March 14, 2025

Project No. M8128.02.031

Re: Siltronic Corporation Comments in Response to NWN's GOU Feasibility Study

Figure
Siltronic Property Areas
Portland, OR

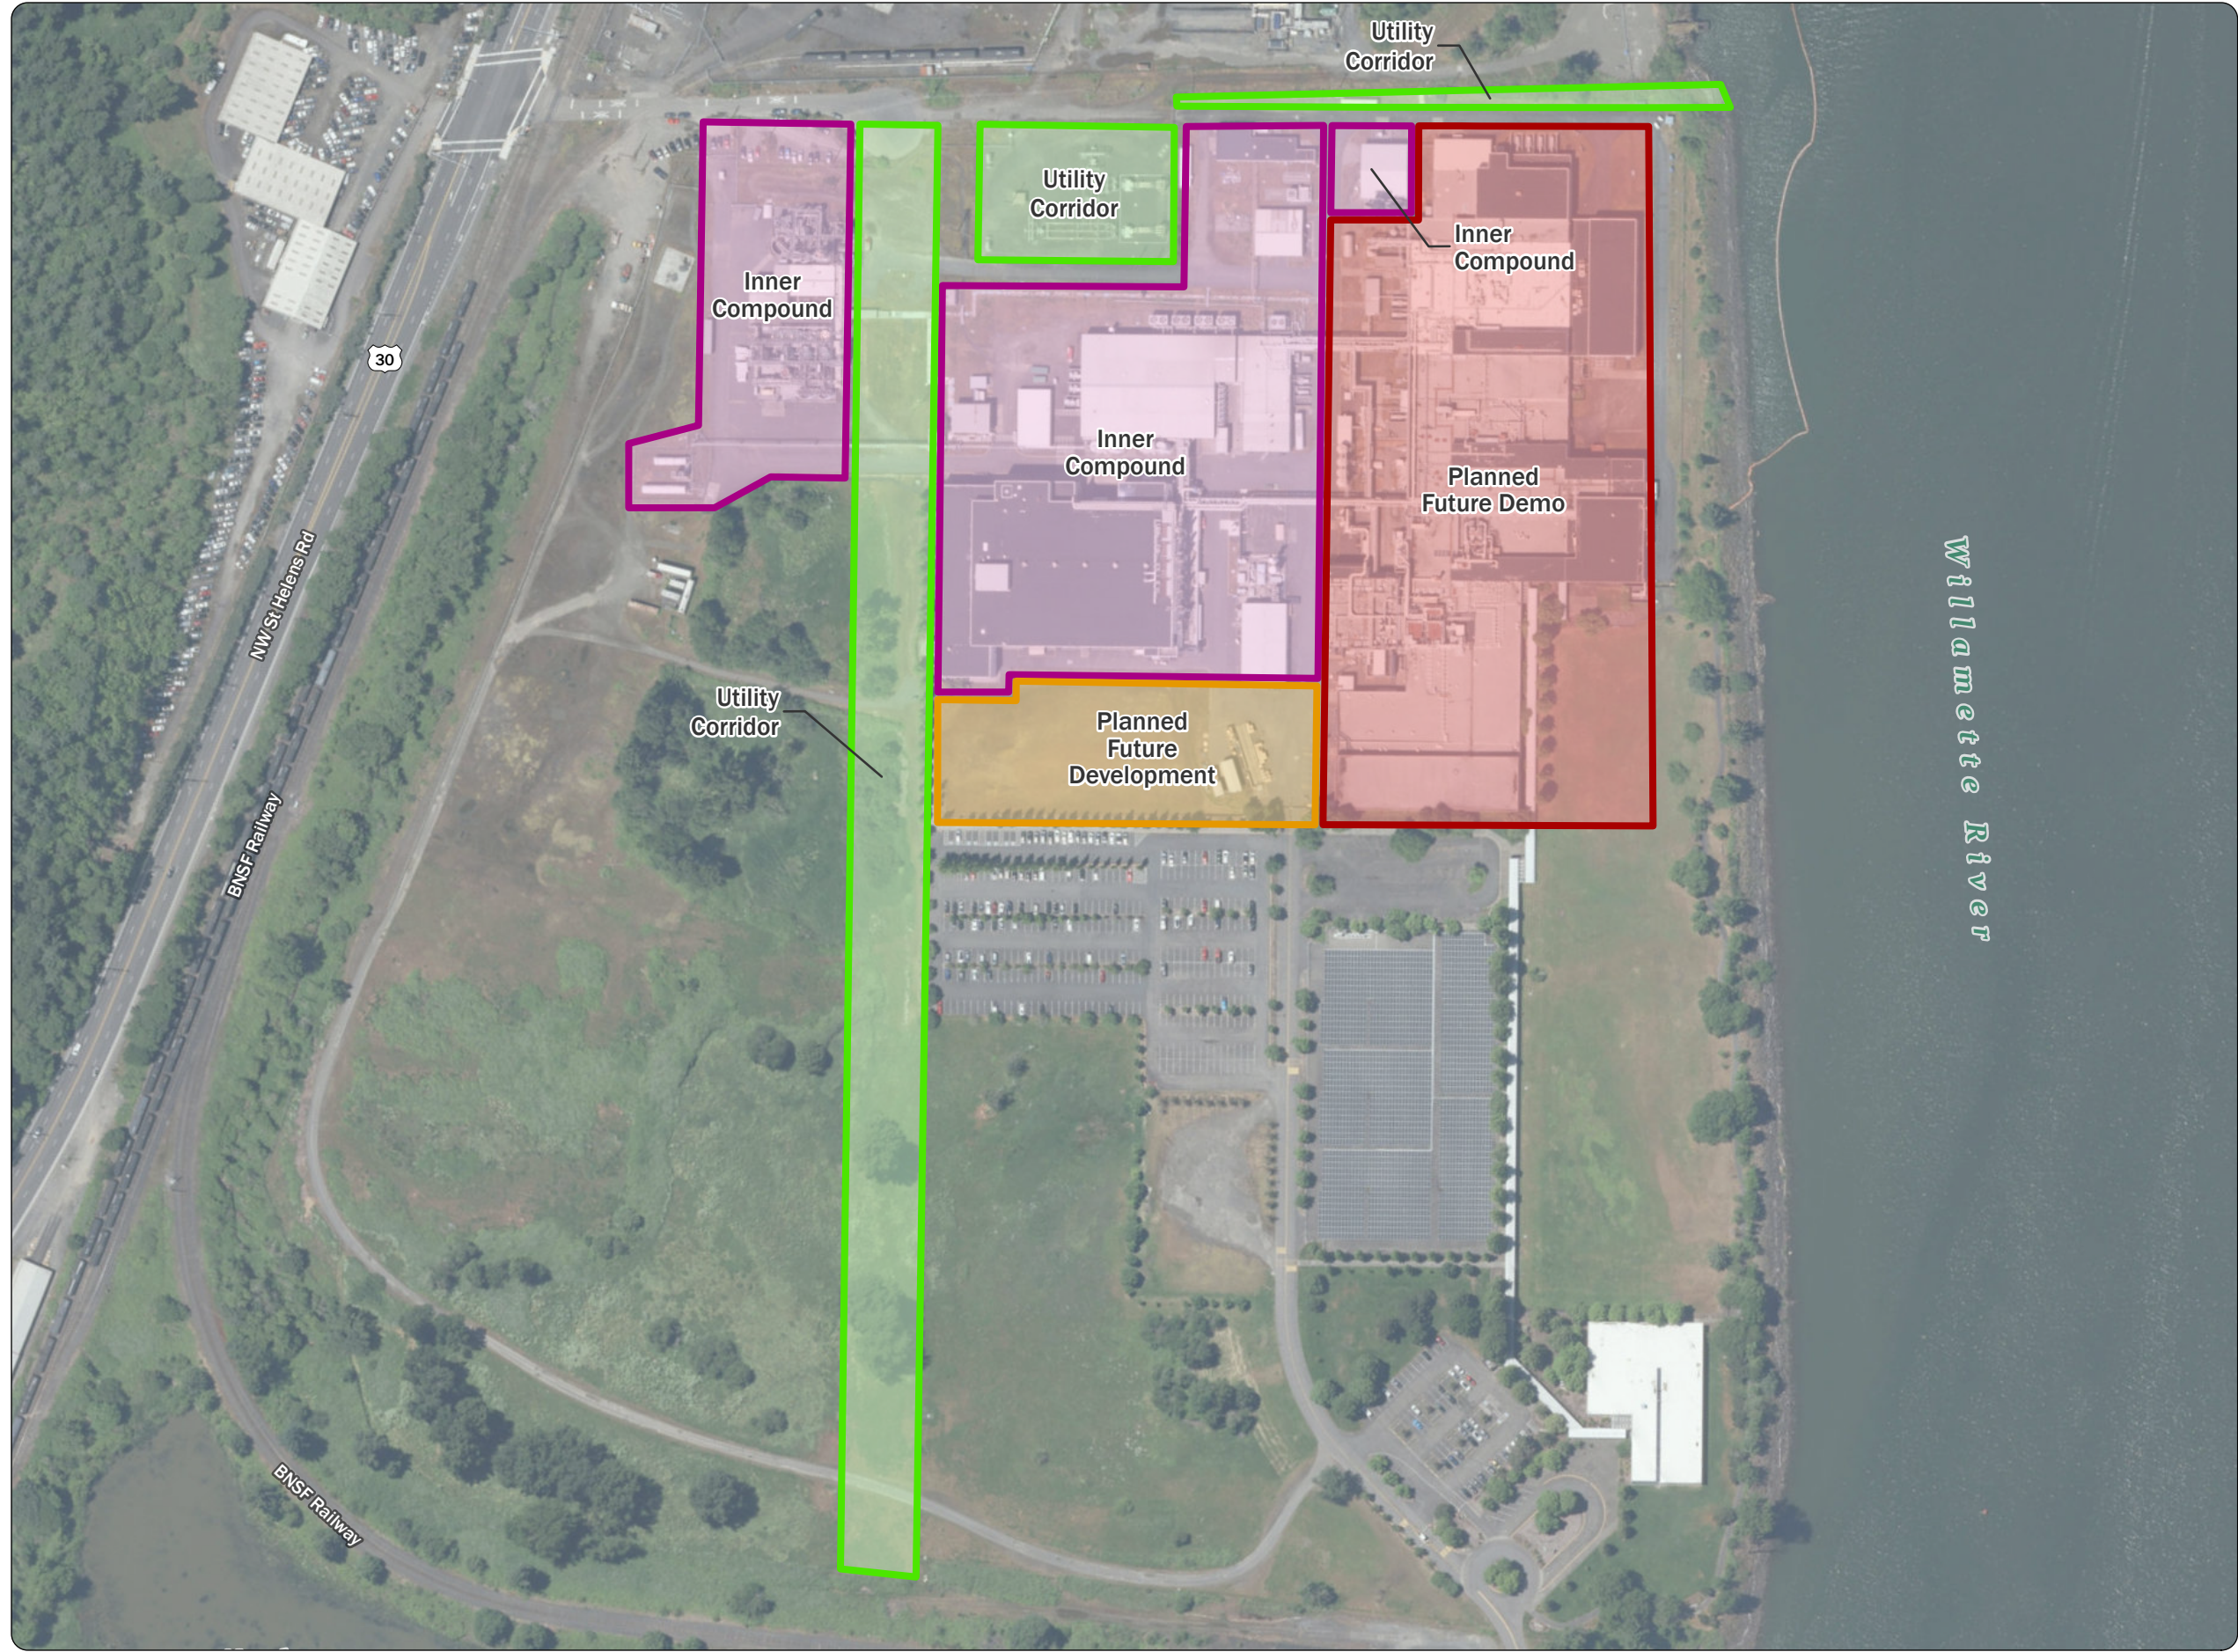
In the FS Report, much of the Siltronic geographic subarea (GSA) of the Gasco Operable Unit (GOU) is characterized as "Potentially Inaccessible Areas" including the Fab 1 footprint. Siltronic has been working with DEQ and NWN to provide additional details regarding the use and inaccessibility of the Siltronic GSA. Refinement of these areas should enable NWN to attain a larger footprint of hotspot remedies than what is currently shown in Figure ES-2 and some of the conceptual cleanup figures (7-2 through 7-5 in the FS Report). Additional details regarding the accessibility of different portions of the Siltronic GSA are presented in the Figure attached to this letter. Areas identified on the Figure as Inner Compound are areas where Siltronic is actively operating, and any remedial actions in this area should be limited to minimally disruptive activities and closely coordinated with Siltronic.

Siltronic has notified both DEQ and NWN that Siltronic plans to demolish Fab 1 and construct a new warehouse building to replace the current uses of Fab 1. At this point, Siltronic does not have a specific timeline for these construction and demolition activities, but envisions that both activities will likely occur within the next 5-10 years. Although no specific timeline has been established, Siltronic's operations necessitate that the new warehouse be constructed before Fab 1 is demolished. The current proposed location for the new warehouse building is shown in the attached Figure. Siltronic recognizes that the sequencing of these construction and demolition activities with the proposed remedial actions described in the FS Report will be critical, and looks forward to coordinating with NWN and DEQ to ensure that this timeline is as efficient as possible.
